RE: REF 19/2023

WENTWORTH HEALTH SERVICE REDEVELOPMENT PROJECT ADDENDUM #1 TO APPROVED REF

Figure 1 – Extract of elevation of proposed change to bedroom suite WEN-A-043 to replace a window with a double-swinging glazed door – as clouded (NBRS)

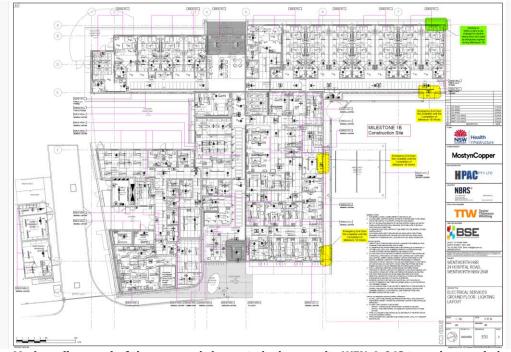
- Introduction of a double-swinging glazed door within bedroom suite WEN-A-043 to replace a window in the same location and to initially and temporarily provide for BCA compliant fire egress whilst both the new and old buildings abut each other preventing the final egress arrangements to be employed. The door will ultimately be retained instead of the window.
- Erection of an awning / canopy addition to the approved maintenance shed to assist with mitigating oil and rain water entering the Council sewer system in proximity of the maintenance shed, following consultation with Council. As the proposed awning is marginally greater than 20m² in area and more than 2.4m above existing ground level, it cannot qualify as Exempt Development and therefore requires a form of planning approval. This REF addendum presents itself as the appropriate vehicle in this instance.

Based on the abovementioned design changes to remove a single window and replace it permanently with a double-swinging glazed door (initially operating as an interim fire escape) as well as the addition of an awning / canopy attached to the maintenance shed, this Addendum REF is both minimal and in part administrative in nature. It does not materially affect the approved project or works in any other way than adjusting the new buildings to meet temporary and permanent needs of the development.
